Pre-Construction Minor Works Approval Form

Part 1: Application	
Contractor:	Laing O'Rourke
Project:	Sydney Metro – City and Southwest – Chatswood to Sydenham Central Station Main Works
Application Title: (e.g. Smith St trenching works)	Services investigation (Non-destructive digging) Soil Resistivity Testing and Construction of Overhead Wiring Structures
Application Number:	CSMW 007
Application Date:	Version 1 - 19/6/18 Version 2 – 29/6/18 Version 3 – 04/07/18
Planning Approval:	SSI 15_7400 Mod 2 - Central Walk - Sydney Metro City & Southwest - Chatswood to Sydenham (SSI Mod)
Minor Works Categories: <ul style="list-style-type: none"> Highlight as applicable. If Items 4, 8 or 11 are applicable, this form must be endorsed by an Environmental Representative. 	<ol style="list-style-type: none"> Survey, survey facilitation and investigations works (including road and building dilapidation survey works, drilling and excavation). Treatment of contaminated sites. Establishment of ancillary facilities (excluding demolition), including construction of ancillary facility access roads and providing facility utilities. Operation of ancillary facilities that have minimal impact on the environme

Locations of new OHW structures (grey boxes)

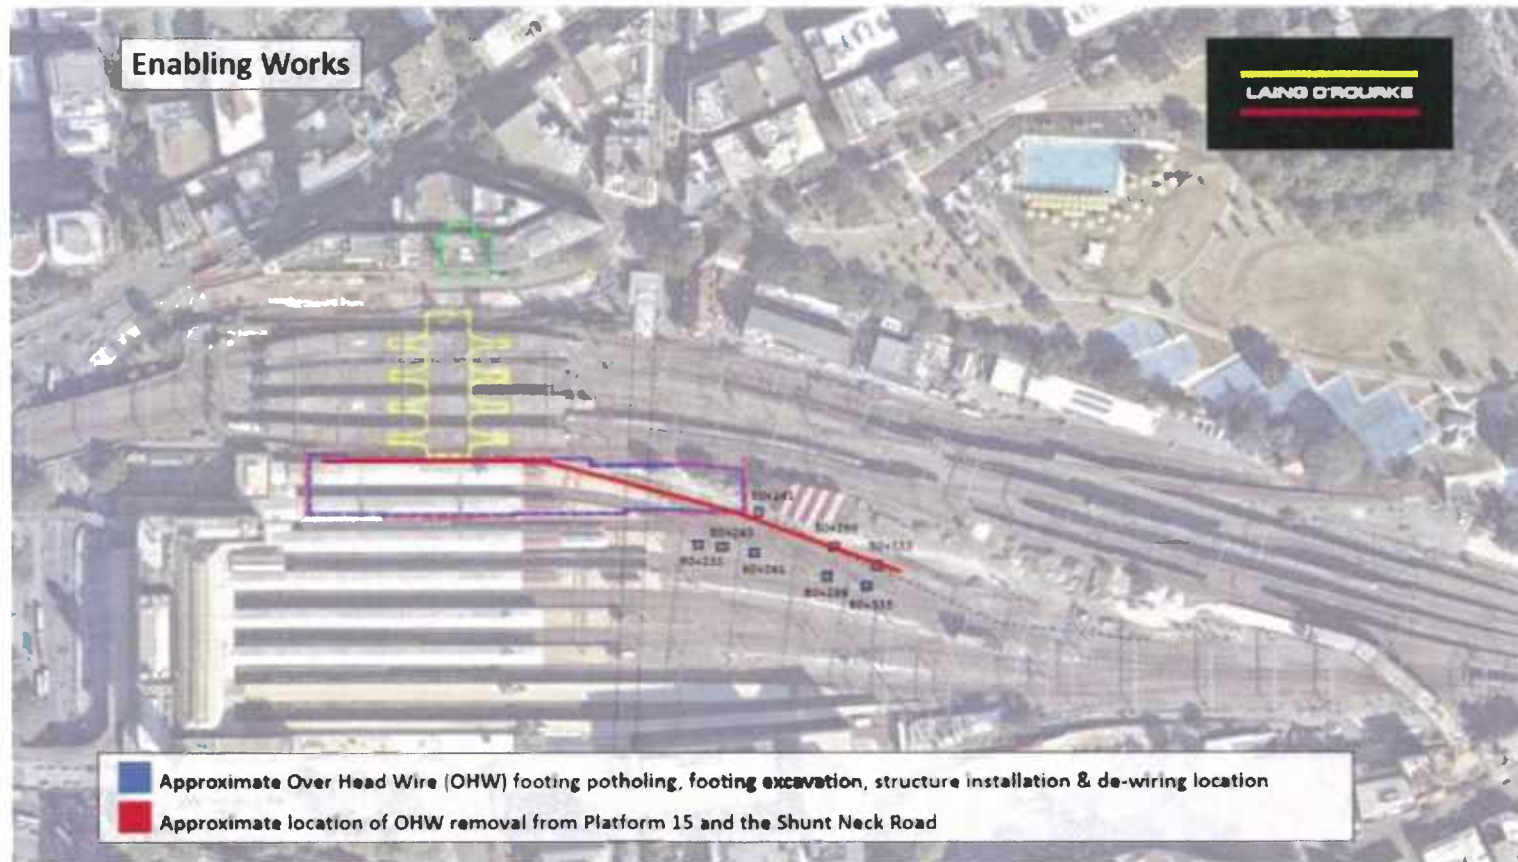
Excavation and installation of footings and OHW structures are required to be constructed at chainages B0+231, B0+243, B0+261, B0+299 and B0+333 (see Figure 1). This would involve the following stages:

- The installation of new overhead wire structures in the locations shown in Figure 1, consisting of the single mast type in close proximity to the platforms (two structures at chainages B0+231 and B0+243) and the over-track dual mast type further to the south (three structures at chainages B0+261, B0+299 and B0+333).
